**EPA Superfund
Explanation of Significant Difference
for the Record of Decision:**

**PSC Resources,
Palmer, MA
11/26/1996**

**FINAL EXPLANATION OF SIGNIFICANT DIFFERENCES AND
DESIGNATION OF CORRECTIVE ACTION MANAGEMENT UNIT**

AREAL CONFIGURATION
OF CAMU

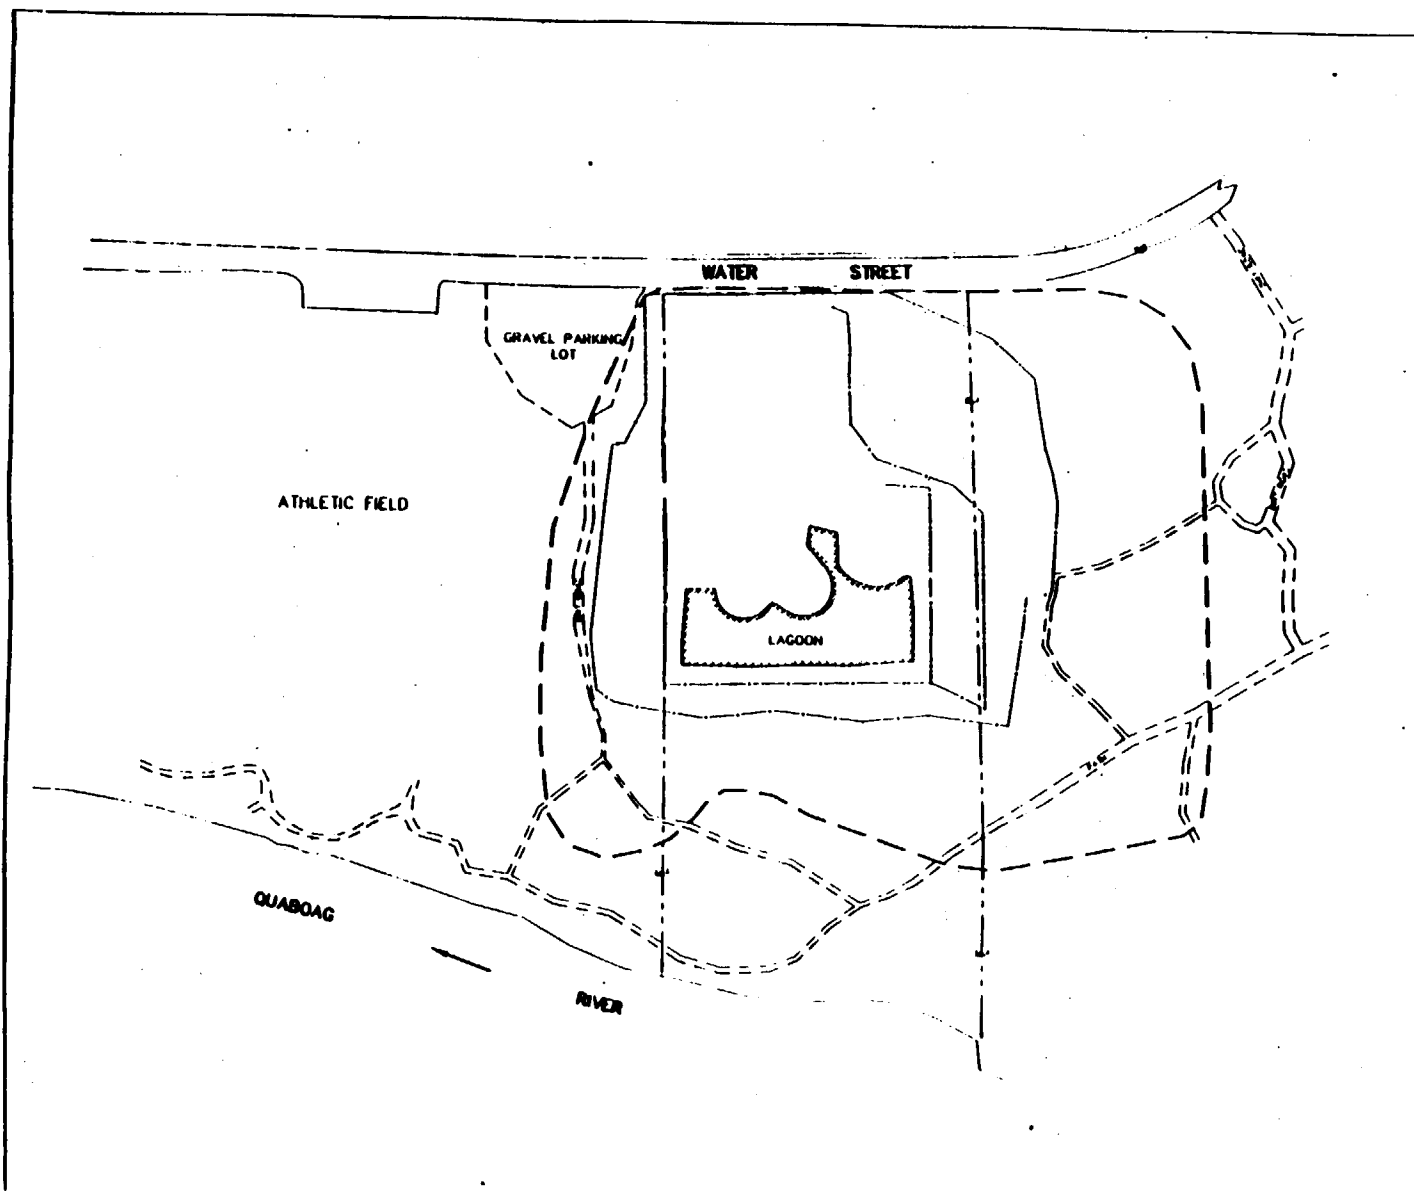
EPA is designating a Corrective Action Management Unit (CAMU) for this site. A CAMU designation is needed for this site to allow temporary storage, stabilization and placement of excavated contaminated materials without triggering the Land Disposal Restrictions (LDRs) and Minimum Technology Requirements (MTRs) intended for hazardous process wastes. The CAMU will facilitate the cleanup plan which addresses contamination at the site. The CAMU covers an area within the PSC Site, including excavation areas, the cap area, the processing area and the staging area (collectively referred to as the Remedial Action Area). The CAMU is shown on Figure 1.

a. Does the entire Superfund site become a CAMU, or just specific areas, and if so which areas?

Under the CAMU designation, the entire Site will be a CAMU (see Figure 1 at the end of the Draft ESD). On a small site like PSC Resources, this will allow some limited flexibility for the Construction Contractor to determine how to best handle the logistics of excavation, staging and materials handling with regard to the stabilization process.
